G.O. No.
~~B.P. No.~~ 2789 (N) Press.
Mis.

Buildings and Roads.
Military Works.

Arm Rack and Accoutrement Shelves.

Plan of the combined — modified to suit Henri Martini rifle, forwarded by the Government of India, ordered to be lithographed and circulated for the information of the officers of the Public Works Department.

ARM RACK FOR THE MARTINI-HENRY INFANTRY RIFLE

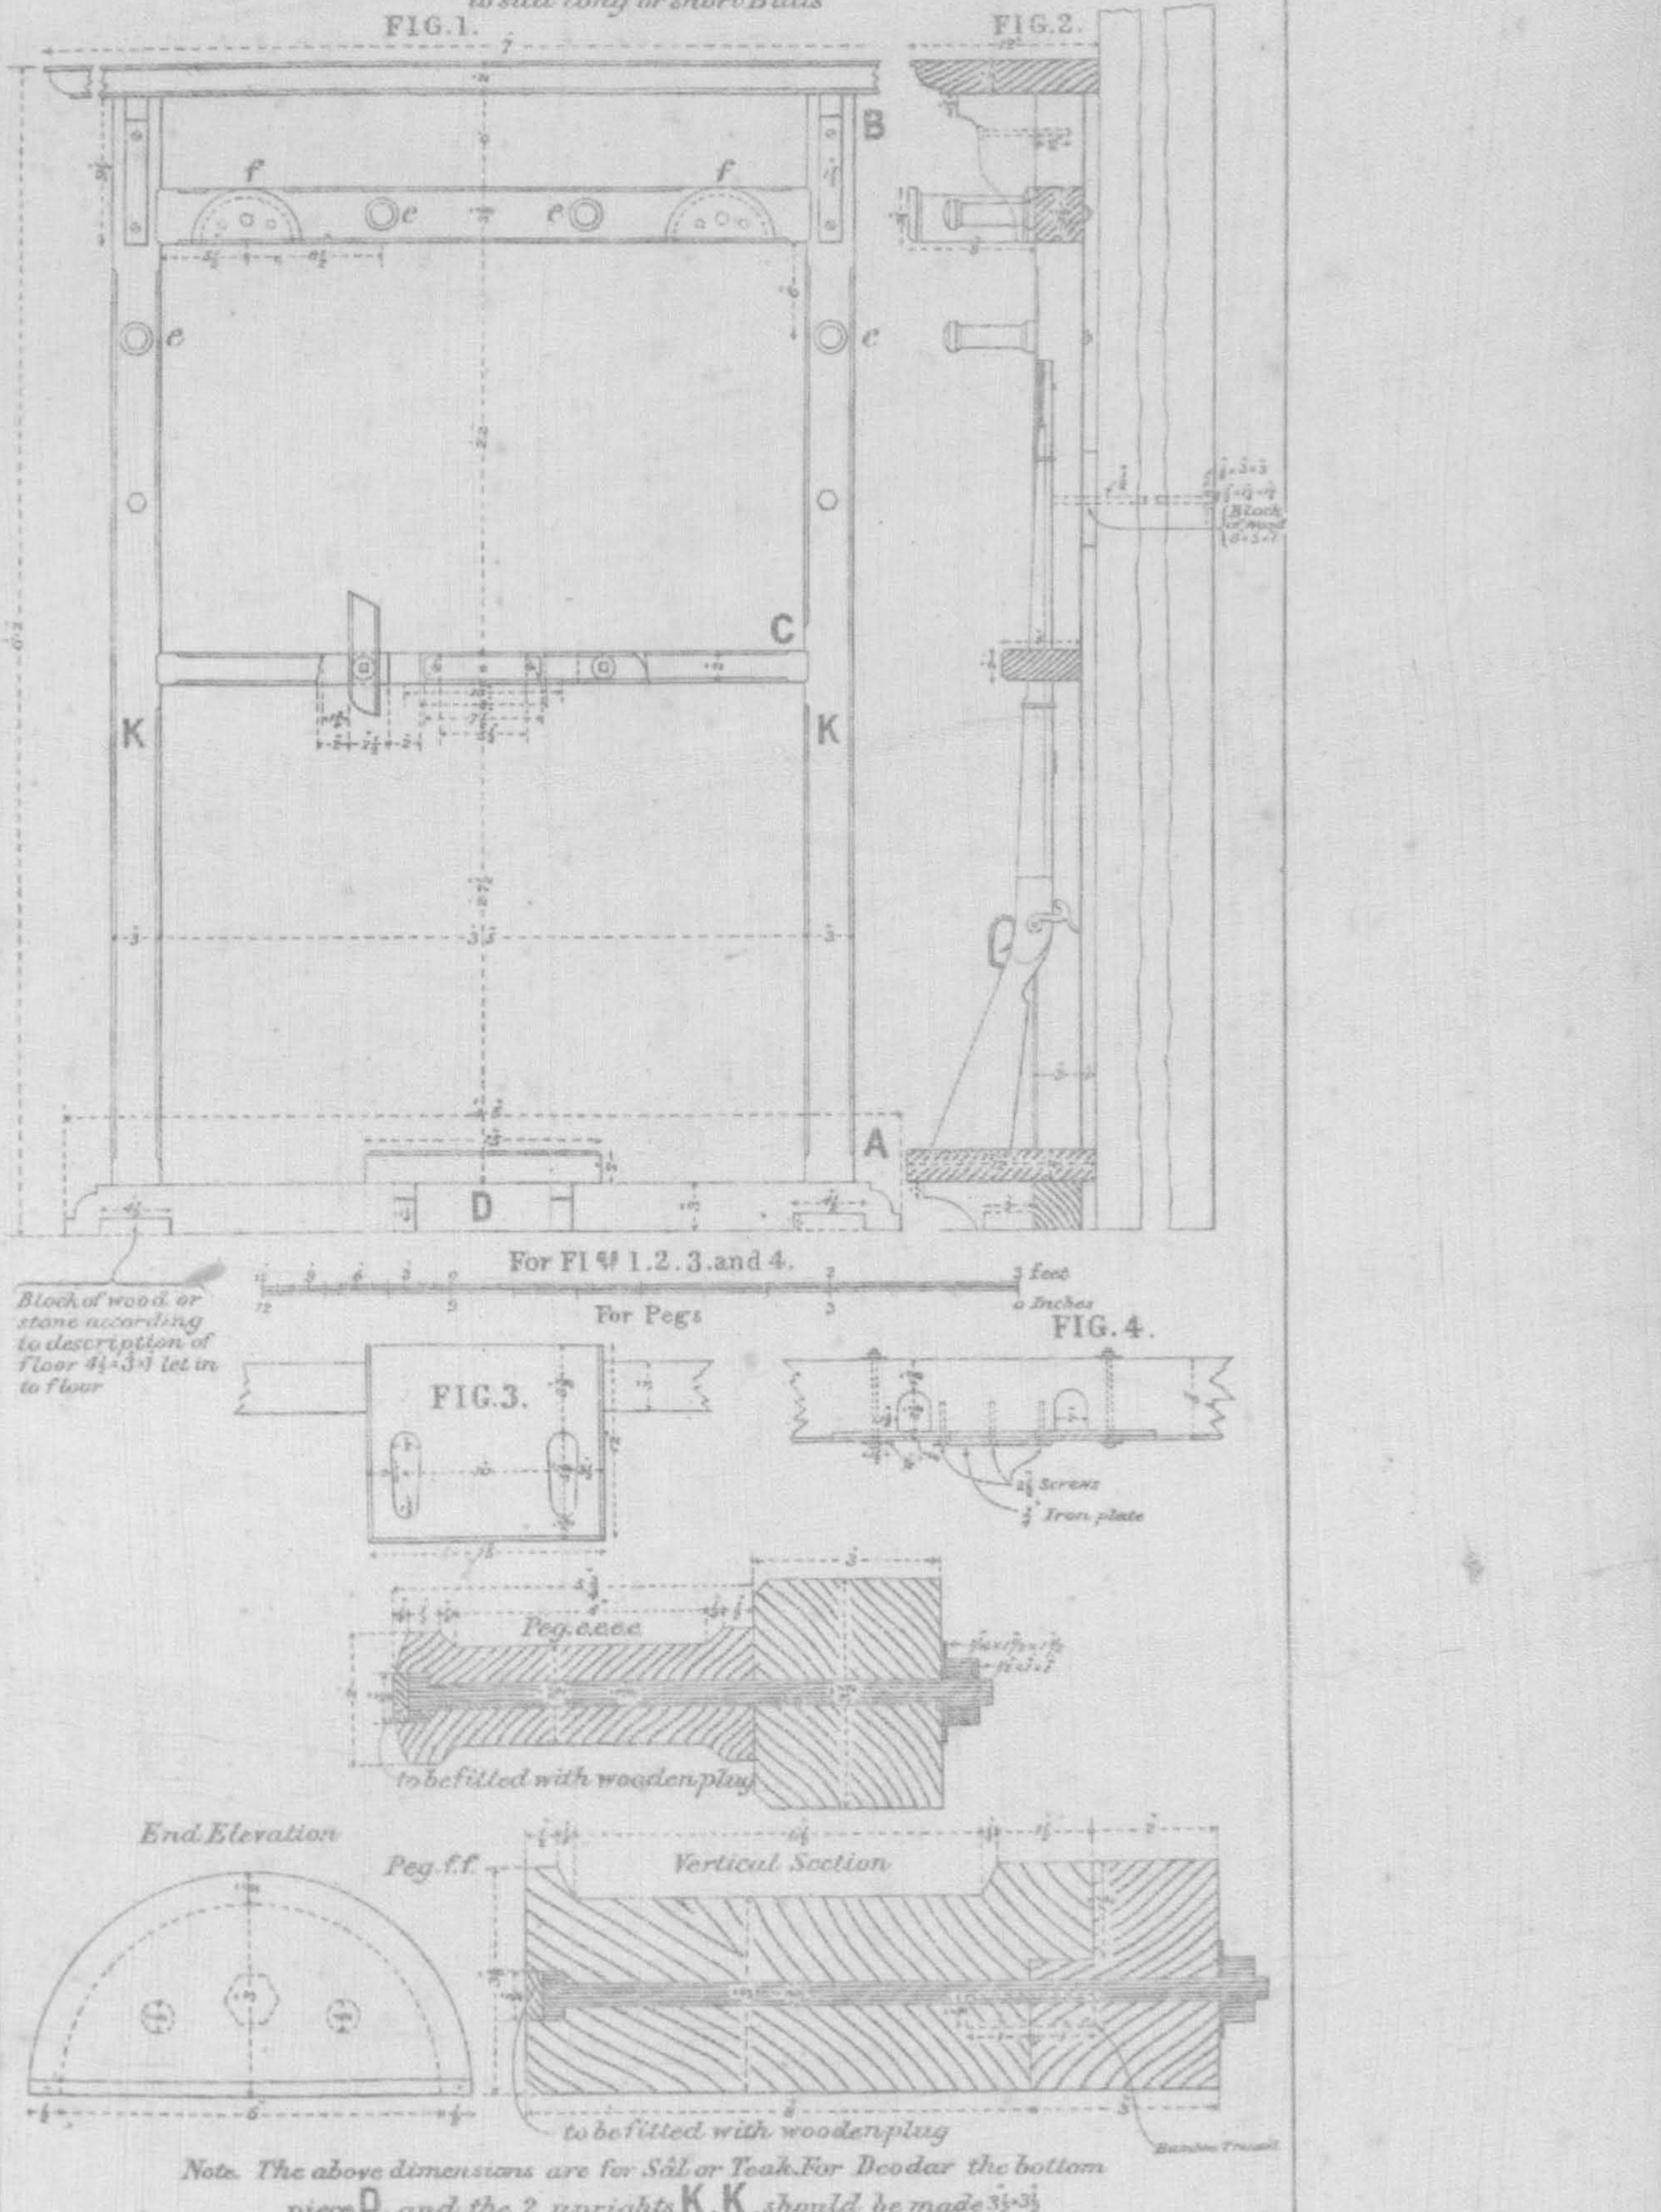
With reference to your docket No. 2231 W., dated the 31st August 1882, I am directed to state that no standard plan of arm-racks for the Martini Henri rifle has been issued, but that the plan of the combined arm-rack and accoutrement shelves, as usually fixed in barracks, has been modified to suit Henri Martini rifle, with either short or long butts. Six copies of this modified plan are herewith forwarded.

With reference to your docket No. 2231 W dated the 31st August 1882, I am directed to state that no standard plan of arm racks for the Martini Henry Rifle has been issued but that the plan of the combined arm rack and accoutrement shelves as usually fixed in barracks has been modified to suit Henry Martini Rifle, with either short or long butts. Six copies of this modified plan are herewith forwarded.

Note. The above dimensions are for Sâl or Teak. For Deodar the bottom piece D. and the 2 uprights K.K. should be made 3½×3½
